PLANNING OBJECTION TO SSD-35609161-MOD-1 (FOR REDUCING BUILDING HEIGHT, ADDING 47 DWELLINGS, ADJUSTING LAYOUTS, SETBACKS, FAÇADES, AND AMENITIES, AND RELOCATING SERVICES—ALL WITHIN THE APPROVED ENVELOPE)

PROPERTY: 1 - 12 HASSALL STREET, PARRAMATTA, 2150 (LOTS 156 DP 1240854)

Figure 1. Proposed Development Site Plan (Red) and 1 Charles Street (Blue)

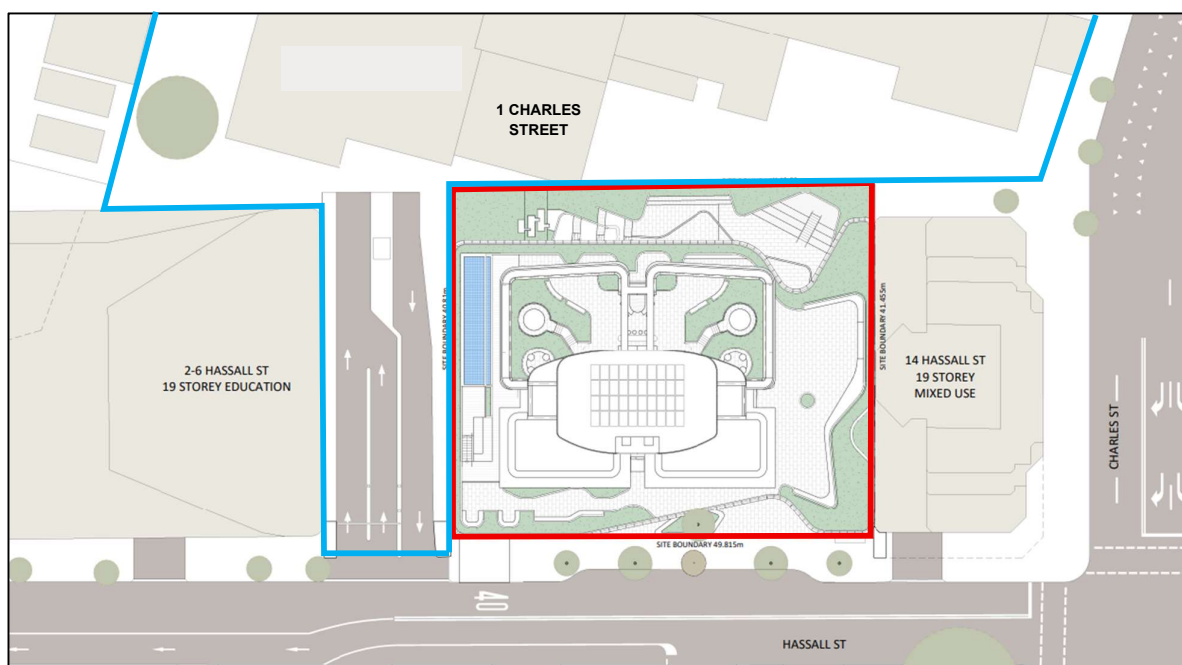
As shown in **Figure 1** above, 1 Charles Street sits immediately to the north of the Site and comprises a 13-16 storey commercial building complex that gains its exclusive access from Hassall Street to the south. The building accommodates the well-established NSW Police Headquarters amongst other commercial tenancies, representing a significant operational presence within the Parramatta CBD.
